CRYSTAL RIVER UNIT 3 NUCLEAR GENERATING PLANT

AMENDMENT TO FACILITY OPERATING LICENSE

Amendment No. 14
License No. DPR-72

SUPPORTING AMENDMENT NO. 14 TO LICENSE NO. DPR-72

FIGURE 6.2-2 FACILITY ORGANIZATION

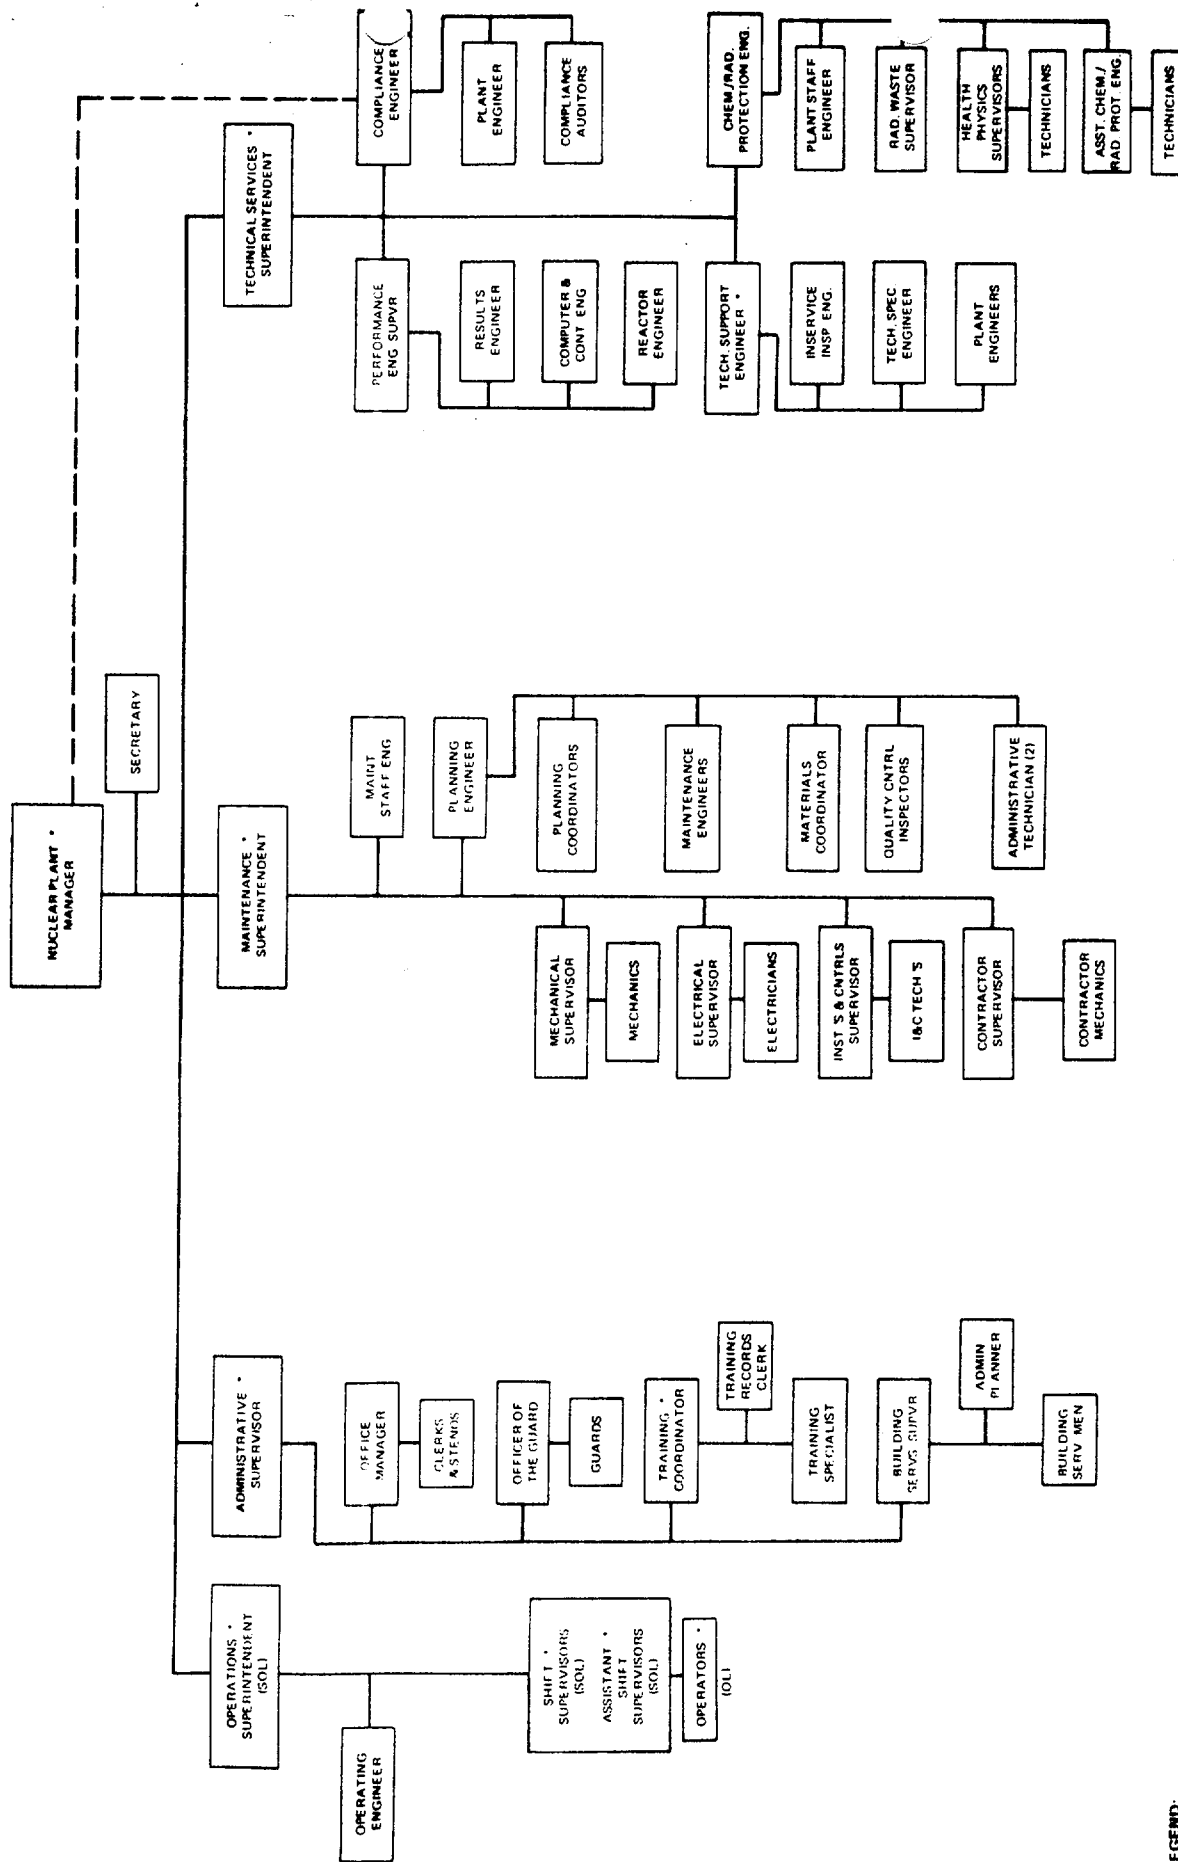
management level between the Compliance Engineer and the Plant Manager and between the Chemical/Radiation Protection Engineer and the Plant Manager. This change is not contrary to established NRC policy. However, the statement made by FPC in their submittal, that the Compliance Engineer has direct access to the Nuclear Plant Manager on "any problems", should be shown on Figure 6.2-2 by a dotted line (plus a footnote describing its meaning) from the Compliance Engineer to the Plant Manager.

The licensee has also proposed that the Technical Specifications be altered to reflect changed position titles. We have reviewed these changes and conclude that the plant staff organization arrangement maintains acceptable lines of authority, includes the necessary areas of expertise, and is acceptable.

This has been discussed with FPC and they have agreed to this modification. In addition, FPC indicated that they do not consider the compliance function a formal part of the Quality Assurance (QA) program. The Compliance Engineer does have Quality Assurance/Quality Control functions as described in Section 1.7.6.7.2 of the current QA program. This has been discussed with FPC and they agree that the Compliance Engineer does have a formal role in the existing QA Program.
